# City of Santa Fe, New Mexico

# memo

**2025-011033-HDRB, 425 Abeyta St.,** Downtown & Eastside Historic District, Studio BOSE, agent for Henry Lanman III, owner, proposes to construct a 2,239 sq. ft. residence to a height of 15'-0" and an 866 sq. ft. garage to a height of 12'-10" with a connecting breezeway, and 551 sq. ft. of portals where the maximum allowable is 15'-1" on a vacant lot. An exception is requested to 14-5.2(E)(2)(b) for a publicly visible window at less than 36" at a corner.

Figure 2: Proposed west elevation

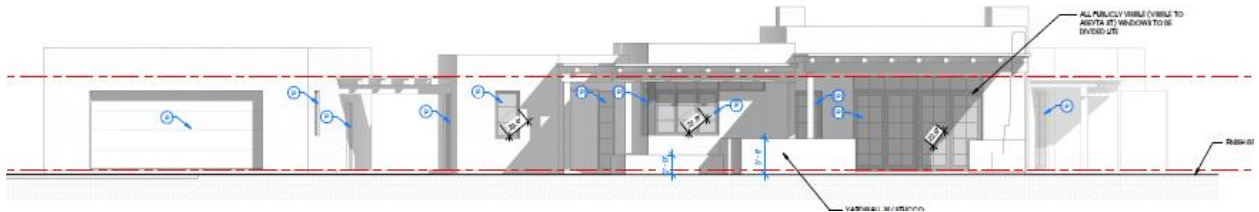
Exception to 14-5.2(E)(2)(b): The applicant requests an exception to construct a publicly visible window at less than 36” at a corner.

Staff Response: The staff finds that this criterion is not met. The Historic Districts ordinance specifically calls out Old Santa Fe Style and Recent Santa Fe Styles as the required designs for buildings in the Downtown and Eastside Historic District; it is not arbitrary, and it is not intended to be a Midcentury architectural style. The Historic Districts are intended to be of an older design style. There are exceptions in the Downtown and Eastside Historic District, but they are exceptions to the code and cannot be considered as a reason for allowing another exception. This design of window is not in the streetscape of Abeyta Street.

Staff Response: The staff finds that this criterion is not met. Having a particular view of the lot is not a hardship but a desire. While it is helpful to see the drive to be alerted when visitors

arrive, a view corridor to the driveway can be accomplished with careful placement of windows that meet the 36” corner rule.

Staff Response: The staff finds that this criterion is not met. There is no evidence that another design element, such as a window located 36” from the corner, was considered. The residence to the north of this property is an example of the Old Santa Fe style, and the houses across the street are good examples of the Recent Santa Fe Style. This proposed residence does not represent the Recent Santa Fe style and does not strengthen the unique character of the area.

Staff finds that the exception criteria have not been met and recommends denial of the exception to place the two publicly visible corner windows at less than 36" from the corner. Otherwise, staff recommend approval of the other elements of the application as they comply with 14-5.2(D)
